SUBJECT: ISSUANCE OF AMENDMENT NO. 60 TO FACILITY OPERATING LICENSE NO. DPR-18, R. E. GINNA NUCLEAR POWER PLANT (TAC NO. M92188)

Amendment No. 60
License No. DPR-18

SAFETY EVALUATION BY THE OFFICE OF NUCLEAR REACTOR REGULATION
RELATED TO AMENDMENT NO. 60 TO FACILITY OPERATING LICENSE NO. DPR-18
ROCHESTER GAS AND ELECTRIC CORPORATION
R. E. GINNA NUCLEAR POWER PLANT
DOCKET NO. 50-244

Figure 5.4-2
 Fuel Assembly Burnup Limits in Region 2

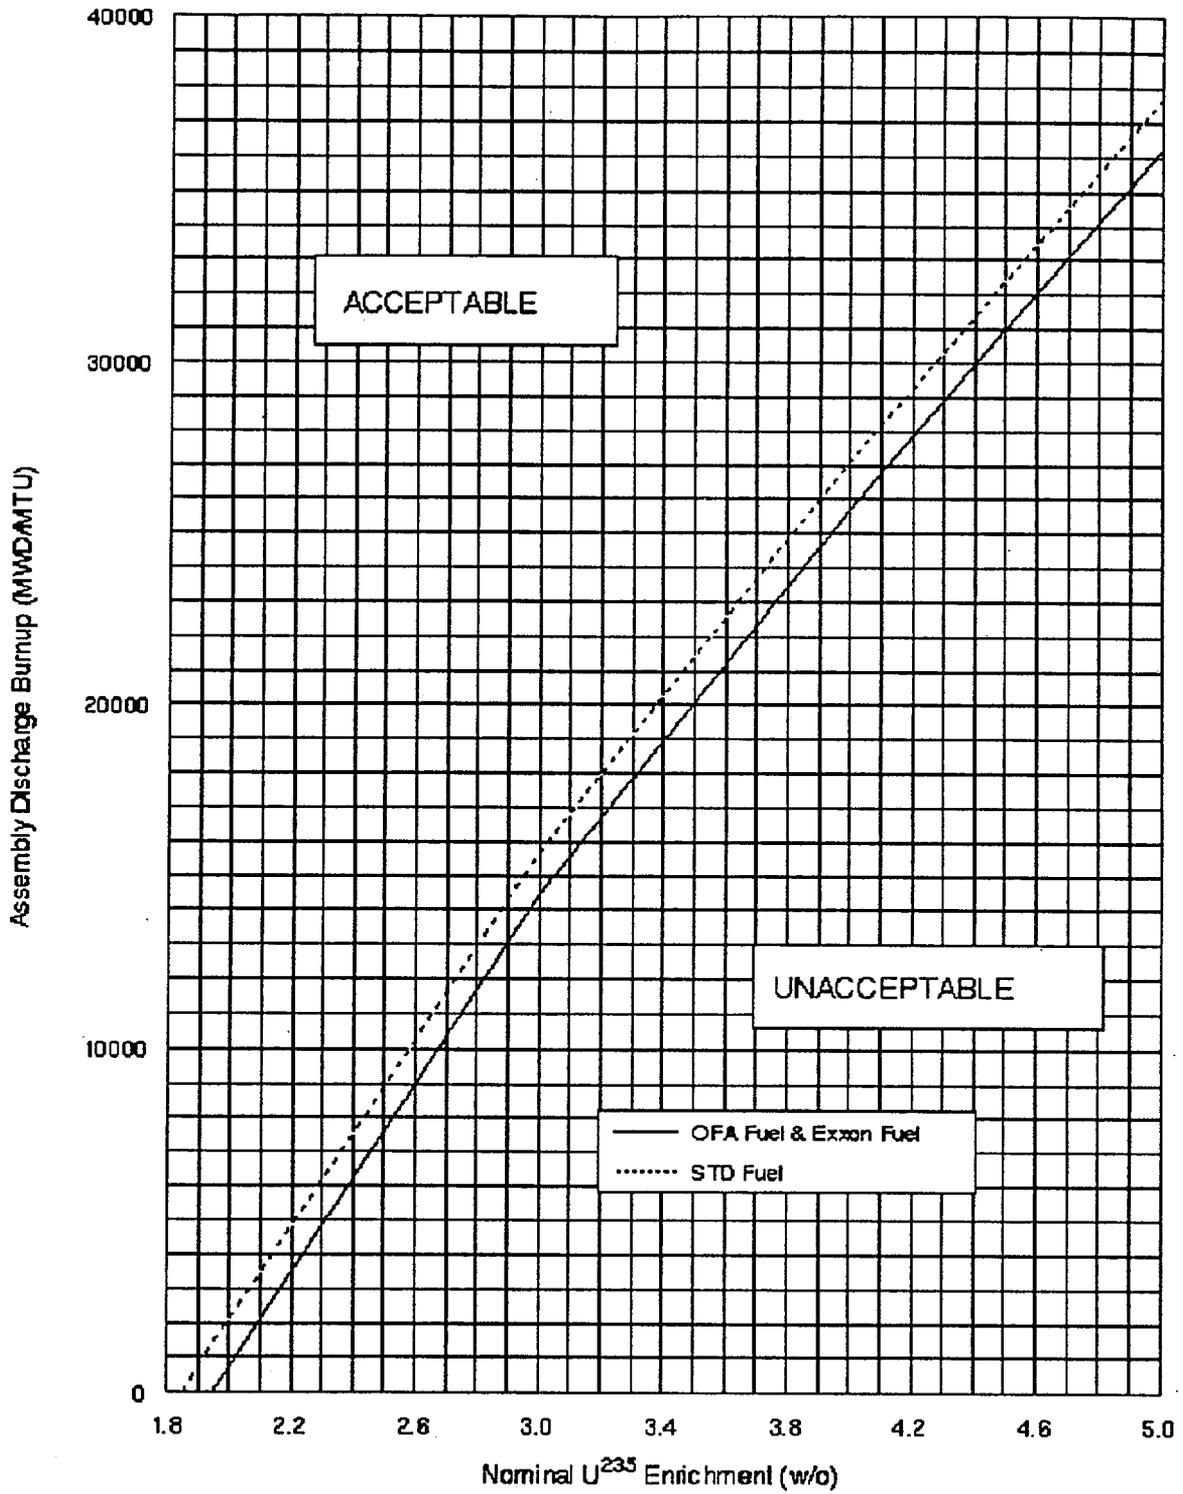
The two curves of Figure 5.4-2 divide the fuel assembly designs into two groups. The first group is all fuel except Exxon fuel delivered prior to January 1, 1984, which incorporates all Westinghouse HIPAR designs used at Ginna.⁴ The second curve is for all Exxon fuel, as well as the Westinghouse Optimized Fuel assembly design delivered to Ginna beginning in February 1984.³

The calculations of fuel assembly burnup for comparison to the curves of Figure 5.4-2 to determine the acceptability for storage in Region 2 shall be independently checked. The record of these calculations shall be kept for as long as fuel assemblies remain in the pool.

In order to store Westinghouse 14x14 OFA as well as Westinghouse STD and Exxon 14x14 assemblies with enrichments up to 5.0 w/o U-235, the concept of burnup credit reactivity equivalencing was used. This is predicted upon the reactivity decrease associated with fuel depletion and has been previously accepted by the staff for spent fuel storage analysis. For burnup credit, a series of reactivity calculations are performed to generate a set of initial enrichment versus fuel assembly discharge burnup ordered pairs which all yield an equivalent K_{eff} less than 0.95 when stored in the spent fuel storage racks. The results indicate that a fresh OFA 1.95 w/o enriched fuel assembly yields the same rack reactivity as an initially enriched 5.0 w/o OFA depleted to approximately 36,200 MWD/MTU. Since the Westinghouse 14x14 STD is more reactive than the Westinghouse 14x14 OFA fuel at the low enrichment limit for the Region 2 rack, a separate burnup credit curve was determined for the STD fuel. In addition, since the Exxon 14x14 fuel is less reactive than the Westinghouse OFA, the Westinghouse 14x14 OFA burnup credit curve may be used for the Exxon 14x14 fuel. A reactivity uncertainty of 0.0121 K (reactivity increase) was applied to the burnup credit curves. This is consistent with current practice and is acceptable.

- 5.4.3 In Region 2 of the spent fuel storage racks, fuel is stored in a close packed array utilizing fixed neutron poisons in each of the stored locations. For discharged fuel assemblies to be stored in Region 2, (1) 60 days must have elapsed since the core reached hot shutdown prior to discharge and (2) the combination of assembly average burnup and initial U-235 enrichment must be such that the point identified by these two parameters on Figure 5.4-2 is above the line applicable to that particular fuel assembly design, therefore assuring that $K_{eff} \leq 0.95$.
